CONSTRUCTION COMMITTEE MEETING AGENDA

DATE: **Tuesday, June 18, 2024**
TIME: **9:00 a.m.**
PLACE: **Carl T. Langford Board Room, Orlando International Airport, One Jeff Fuqua Blvd., Orlando, FL 32827**

CONSTRUCTION COMMITTEE MEETING
CHANGE ORDER AGENDA
Tuesday, June 18, 2024

Exhibit Provided in initial RFI

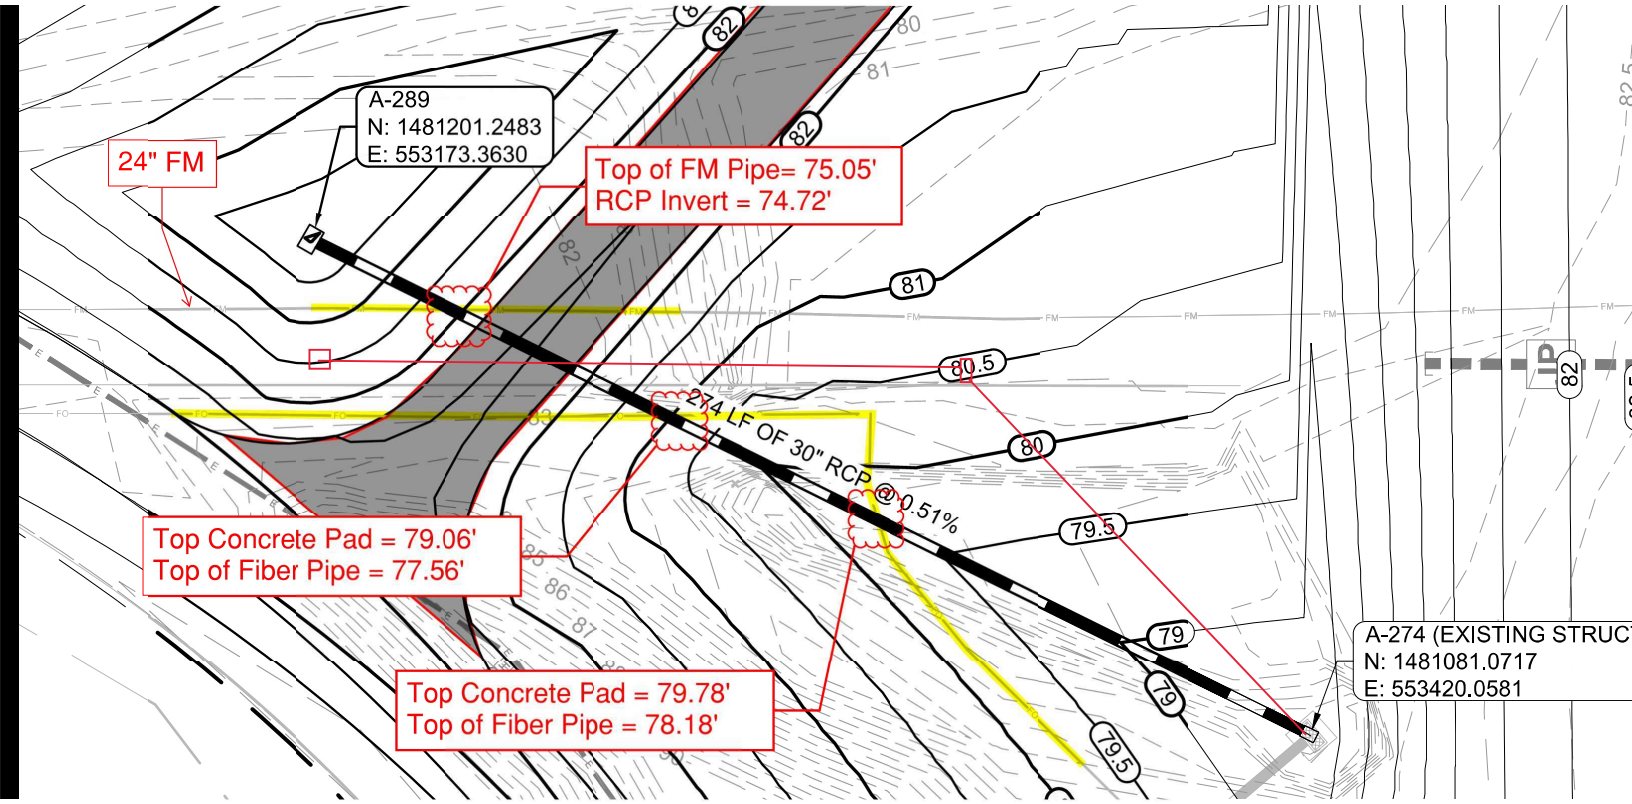
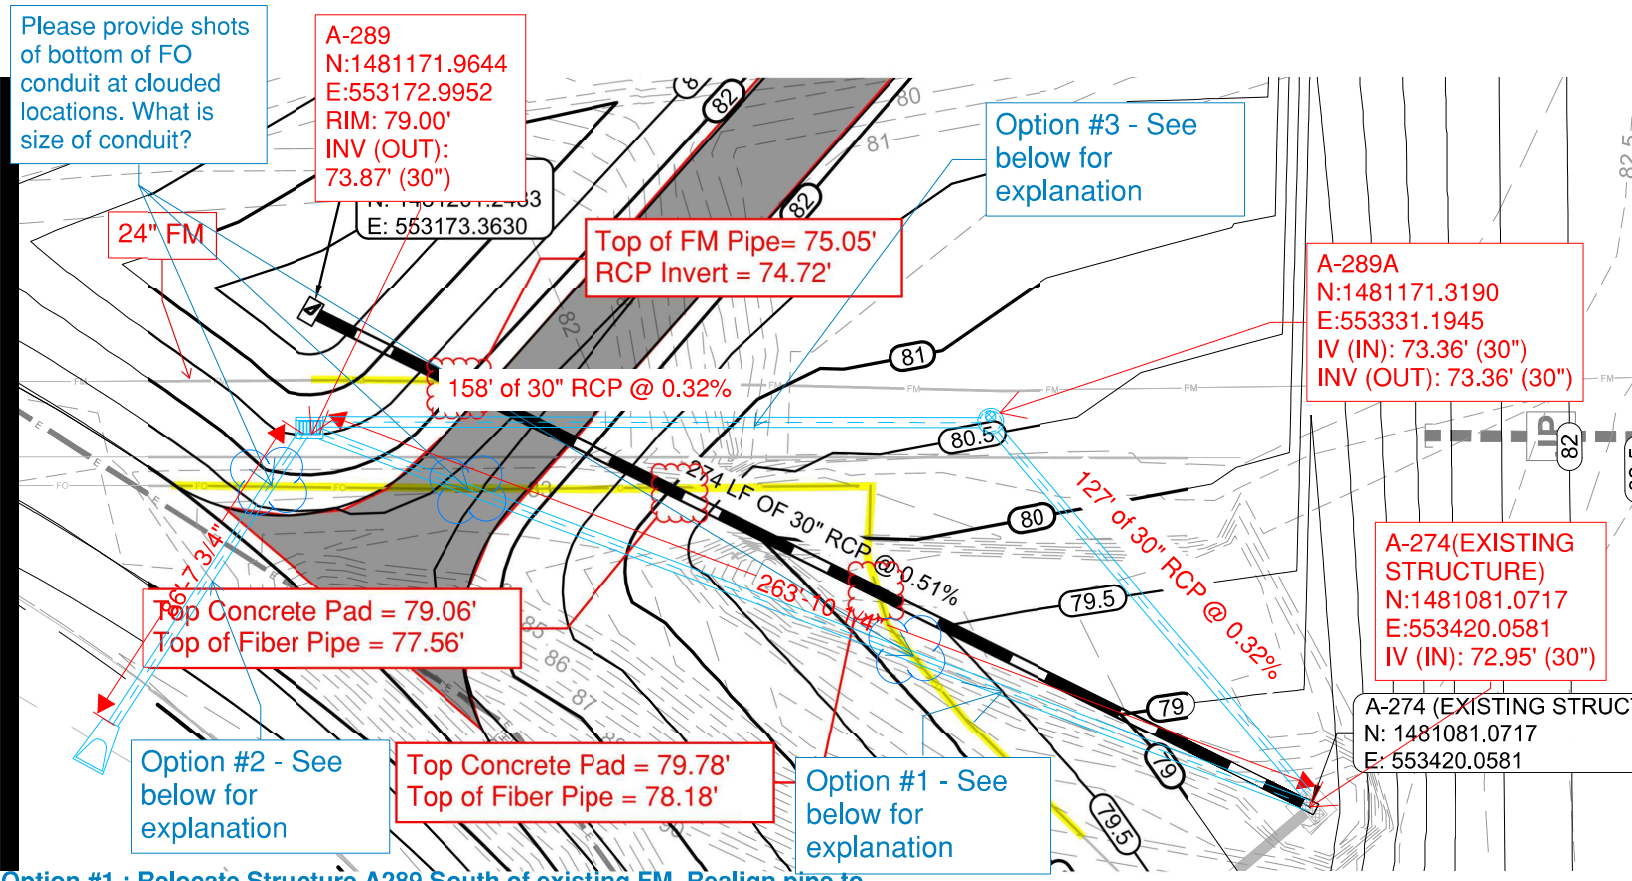
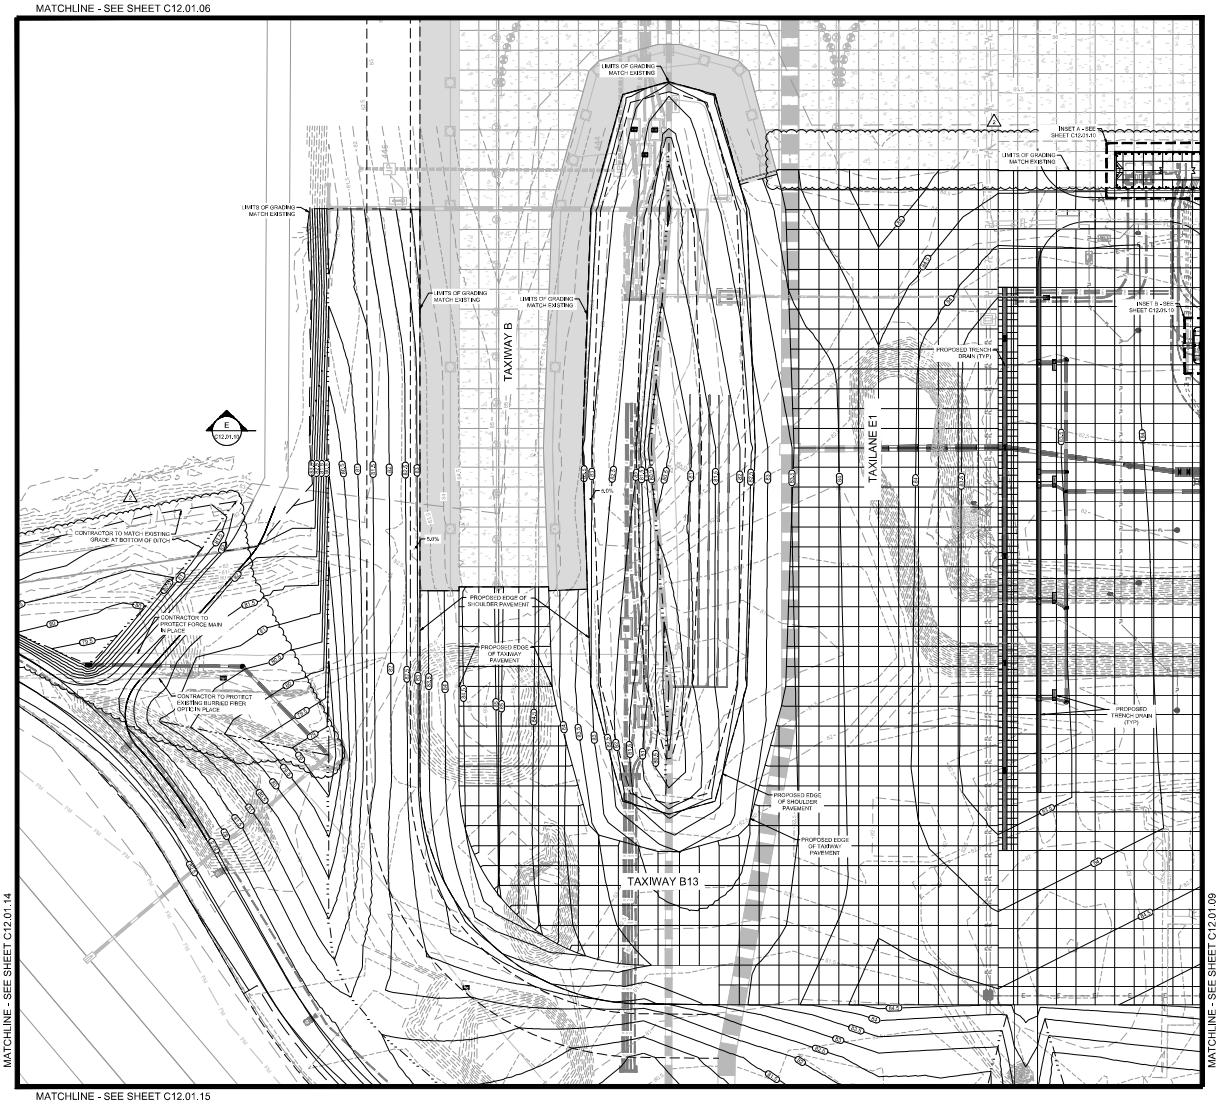
DESCRIPTION OF CHANGE TO CONTRACT: Relocate structure A-289 and modify 30-inch RCP run between A-289 & A-274 due to 24-inch sanitary force main and fiber optic cabling conflicts. The new proposed drainage plan requires an additional 11 LF of 30-inch RCP and 1 additional inlet A-289A.

1. **Unforeseen Condition:** Modify location of structure A-289, add 11LF of 30" RCP and a new inlet to avoid conflicts with existing 24" Sanitary Force Main and Fiber Optic cabling. This change was generated by RFI #7 and issued in Bulletin #4. This change order resolves all costs associated with Bulletin #4

Refer to the attached drawing showing our findings of the existing 24" force main and fiber optic in conflict with the proposed 30-in storm drainage pipe that crosses the proposed VSR.

Option 1: Relocate Structure A289 south of the existing FM. Realign storm pipe to connect from structure A289 to structure A274. Drop pipe invert in structure A289 approx 1' to maintain clearance underneath existing FO line. EOR believes this to warrant a deductive change order due to decrease length of pipe required. This will require laying pipe underneath the active FO line.

Option 3: Relocate Structure A289 south of existing FM. Provide an additional MH structure (A289A) directly east of A289 and reroute storm pipe directly parallel to the existing FM and existing FO, requiring no crossings. The new structure A289A will then turn at a 45 degree to connect the proposed storm pipe to existing structure A274. This option may result in a slight added cost to the Owner.

Option #1 : Relocate Structure A289 South of existing FM. Realign pipe to connect to A274, passing underneath existing FO line. Need invert of FO conduit to confirm this option is possible. Pipe length = 263'

Option #2: Relocate Structure A289 South of Existing FM. Route storm pipe underneath proposed permanent VSR to outfall via MES to Tradeport Ditch. Requires invert of FO conduit to confirm suitability of this option. Pipe length = 86', and new MES required.

Option #3 : Relocate Structure A289 South of the existing FM. Realign pipe to run parallel to FM and avoid both FO and DM completely. Pipe will connect to a MH and route pipe at a 45 degree bend to the existing structure A-274. Pipe length = 285' Pipe slope = 0.32%
